# **Report on Duke Energy Indiana’s 2024 Integrated Resource Plan**

**Submitted to the IURC on February 13, 2025**

**On behalf of Citizens Action Coalition, Earthjustice,  
Solar United Neighbors, and Vote Solar (“Joint Commenters”)**

**Figure 1. Duke Reference Scenario<sup>39</sup>**

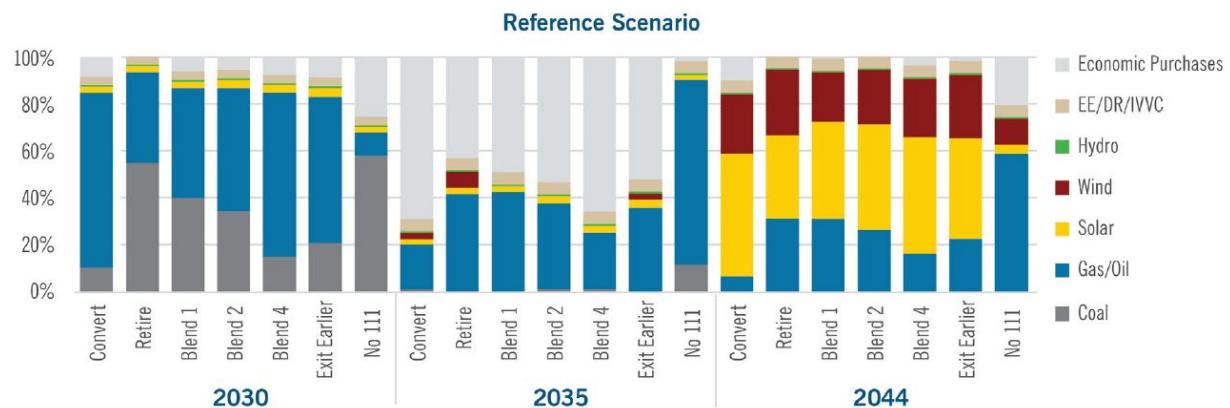
Figure 1 shows the energy mix for the different generation strategies in the Reference Scenario. When the market constraint is removed from the production cost modeling step, there is a significant reliance on economic market purchases in 2035 for all generation strategies with the exception of the “No 111” strategy. This proportion of economic purchases in 2035 significantly decreases by 2044, when those purchases are offset by solar and wind energy. While we understand that Duke has a significant number of modeling runs to manage for an IRP, it would be helpful and informative for additional testing on this result, whether that be through adding a constraint into the production cost modeling step, adding a hurdle rate to the market price, or accelerating renewable resources.

**Figure 2. Unmanaged charging with significant charging at home<sup>45</sup>**

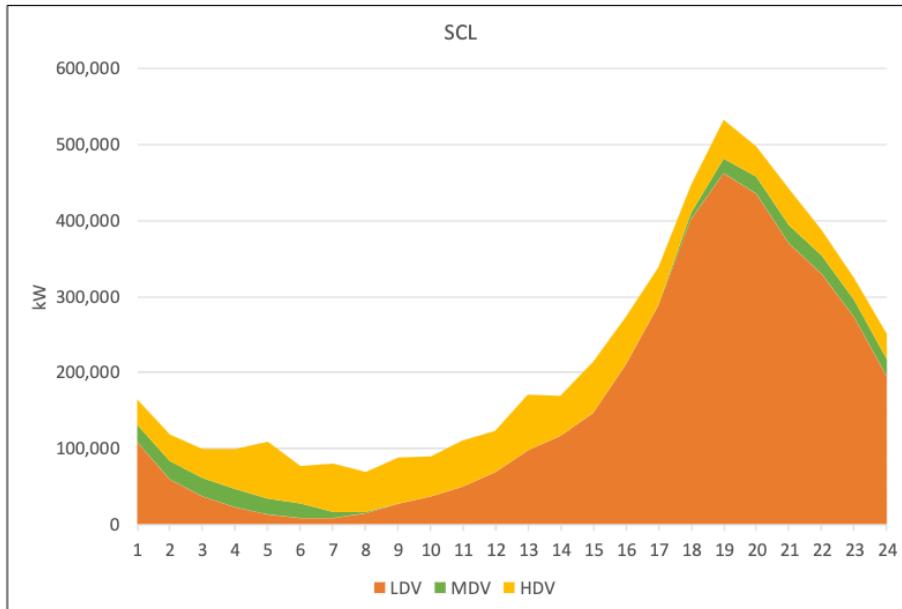
We recommend that Duke remove EV and new large load customers from the projected forecast and model EVs with a profile for each weather year that can incorporate weather and assumptions around charging. For new large load customers with a flat or consistent load factor, those can be modeled as a negative generating unit that has the same shape across each weather year.

Assumptions around the charging patterns for EVs may impact the risk hours for EUE in the SERVM model. We think it's important to represent these loads explicitly to help derive the value of different scenarios of managed charging, but this can only be accomplished if EV load is not

baked into the load forecast. For example, the following are charging load profiles for Seattle City Light but, based on our experience, are generally representative for other regions as well. Figure 2 represents a shape of unmanaged charging with most residential customers beginning charging upon arriving at home. Figure 3 represents a scenario in which charging largely occurs at home but is managed so that charging occurs in the early morning hours.

**Figure 5. Intra-day Hourly Data Center Loads<sup>48</sup>**

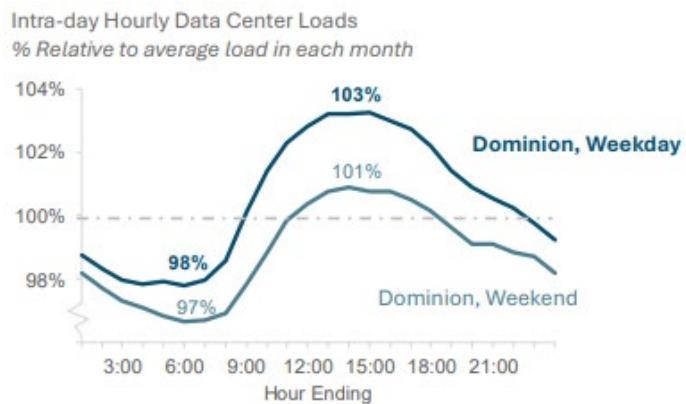
For new large load customers such as data centers, Duke can utilize data from those customers on the expected usage (if they are a new customer to the system) or experienced load (if the customer has been connected to the system). If Duke removes these customers from the forecast input into SERVM and models them like a negative generating unit with its own shape, then intra-day and seasonal variations can still be captured but will more accurately reflect the load since there will be some variation as a result of cooling needs. Figure 4 shows an example of data center load that changes by month and Figure 5 shows an example of data center load on an hourly basis.

**Figure 8. Comparison of Peak Reduction by Dynamic Pricing Treatment**

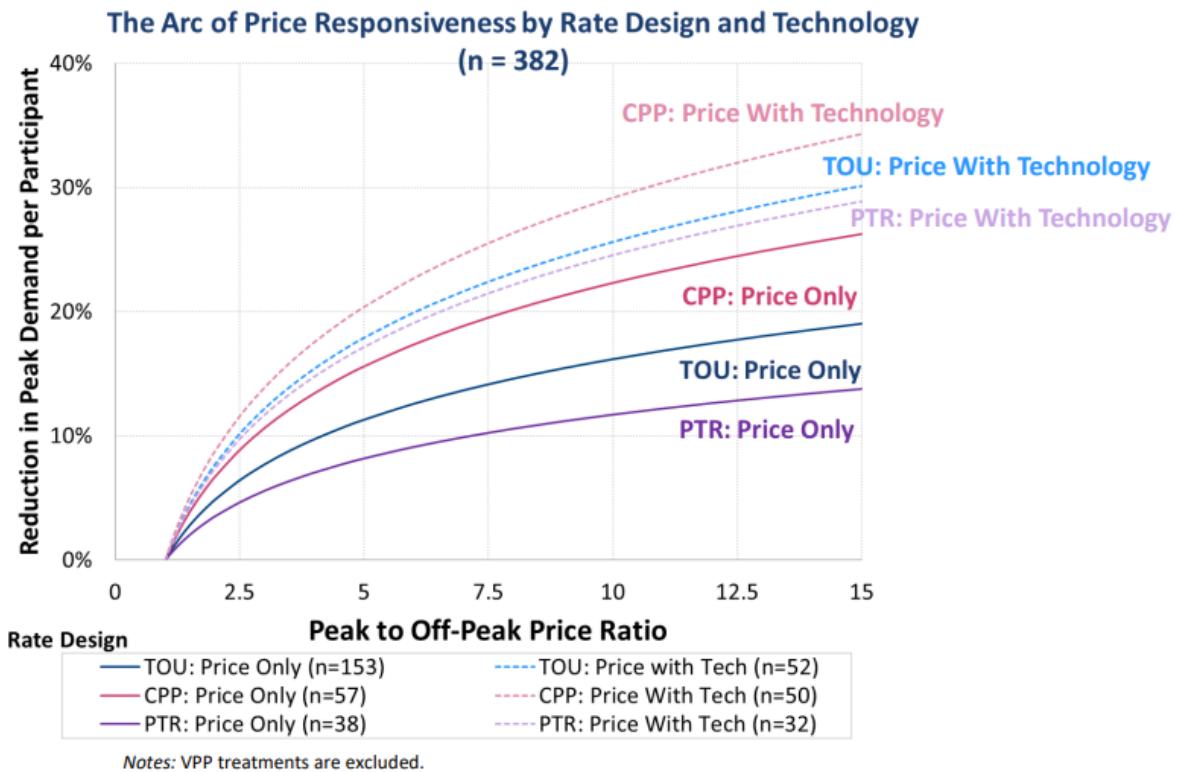
Furthermore, we disagree with the assertion that dynamic pricing products like TOU and RTP that may yield a permanent load shift should be excluded from consideration of a robust assessment of potential. Dynamic pricing products like TOU have been shown to achieve savings of 5-20% of peak, dependent on design parameters, enabling technologies, and education. Figure 8 provides a comparison of peak savings potential for different dynamic pricing treatments with and without enabling technologies (e.g., smart thermostats), showing rates with on-peak to off-peak pricing ratios between 2.5 and 5 achieve between approximately 5% to 20% of peak.<sup>64</sup>

By excluding these resources from its analysis, Duke's assessment significantly underestimates the true capacity savings potential. We recommend that future potential assessments incorporate all dynamic rate opportunities to provide a more accurate and comprehensive evaluation.
